CON. ED. REVISION

THIS REV. IS CLASS "A" PER CI 240-1 IN CONN WITH MODIF OF ECC SYSTEM VALVE CIRCUITRY (PHASE I), MAKE CHANGES AS SHOWN. RELEASED PER CON. EDISON CO. MODIF PROC # ESG-76-2-07

INSERT "A"

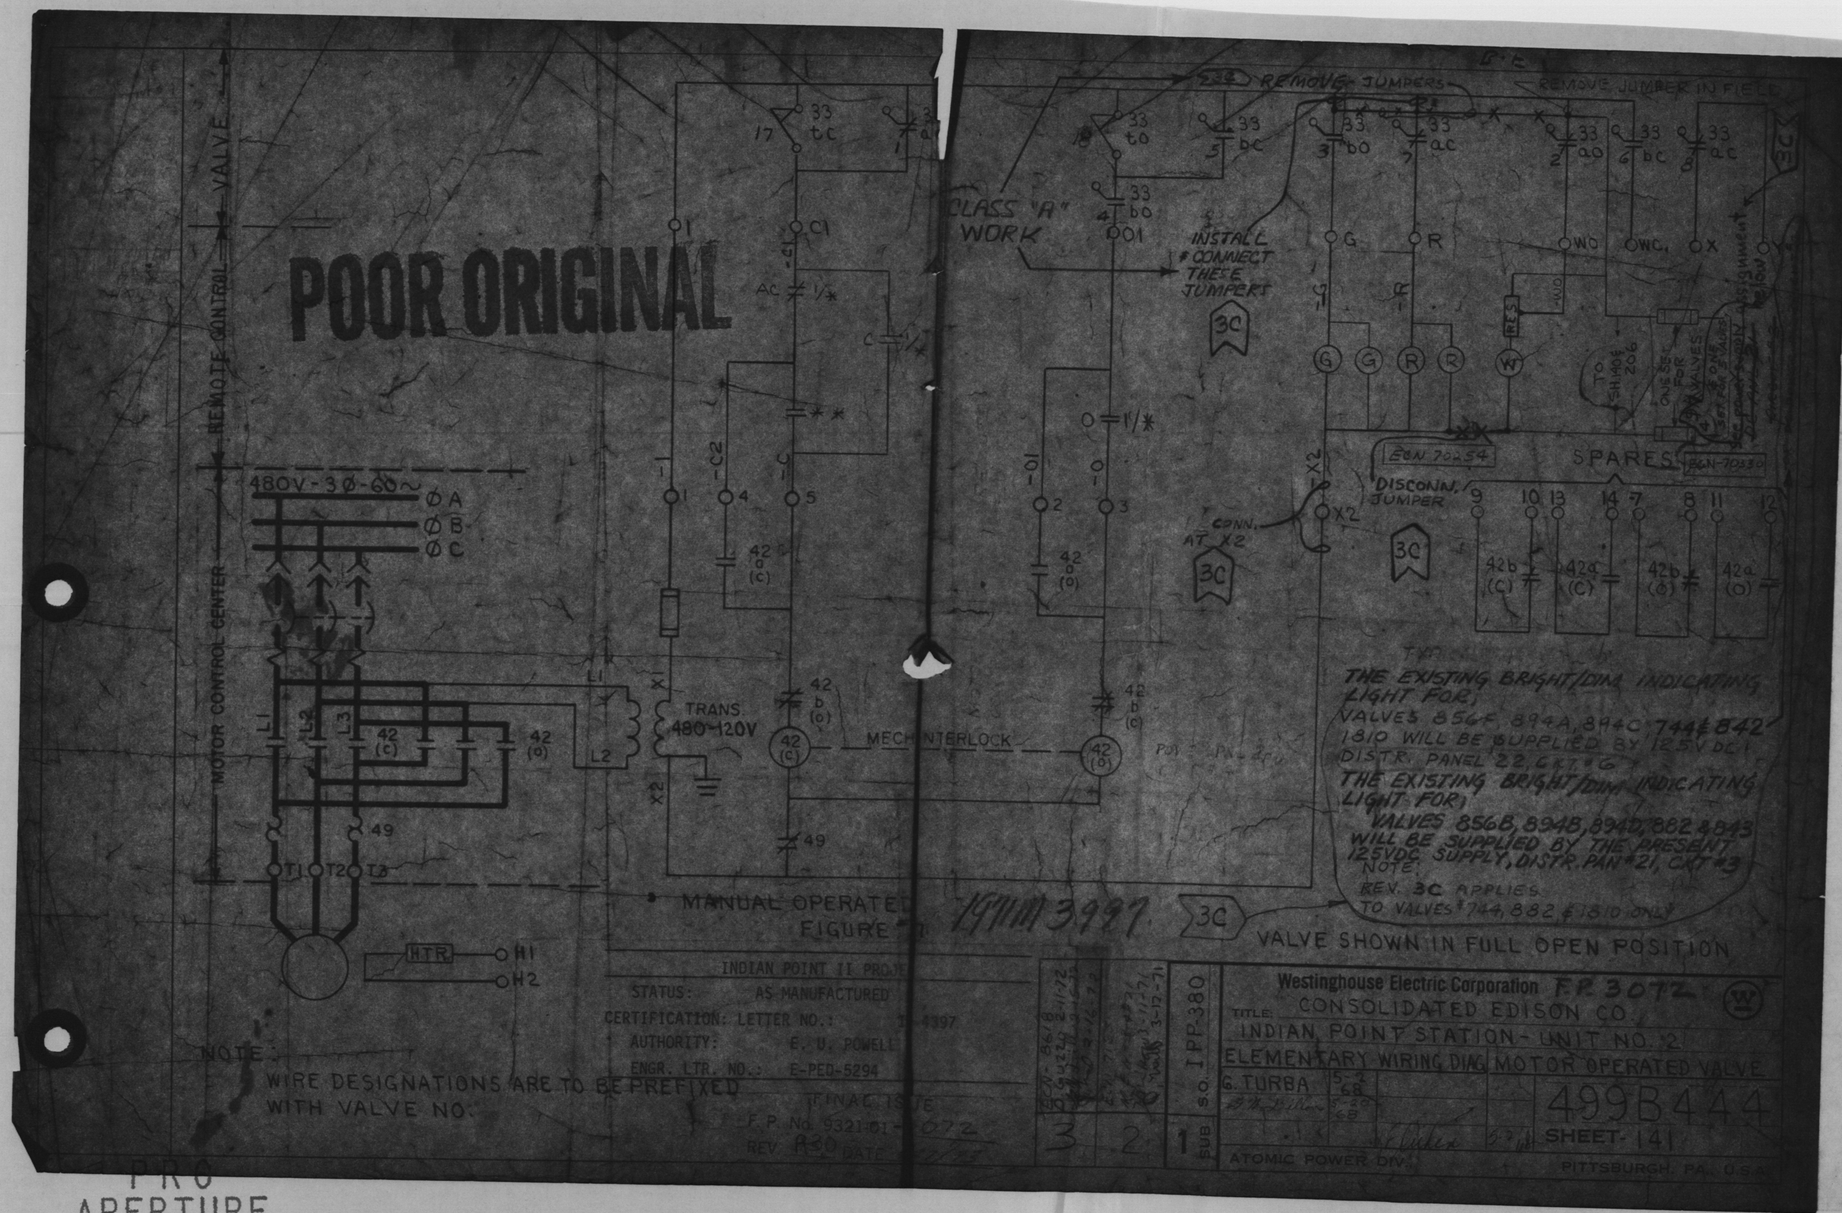
THIS REVISION IS NON-CLASS "A" AS PER CI 240-1 IN CONN. WITH MODIFICATION OF ECC SYSTEM VALVE CIRCUITRY (PHASE #1) MAKE CHANGES AS SHOWN THIS REVISION APPLIES FOR VALVES 744, 1810 & 882 ONLY
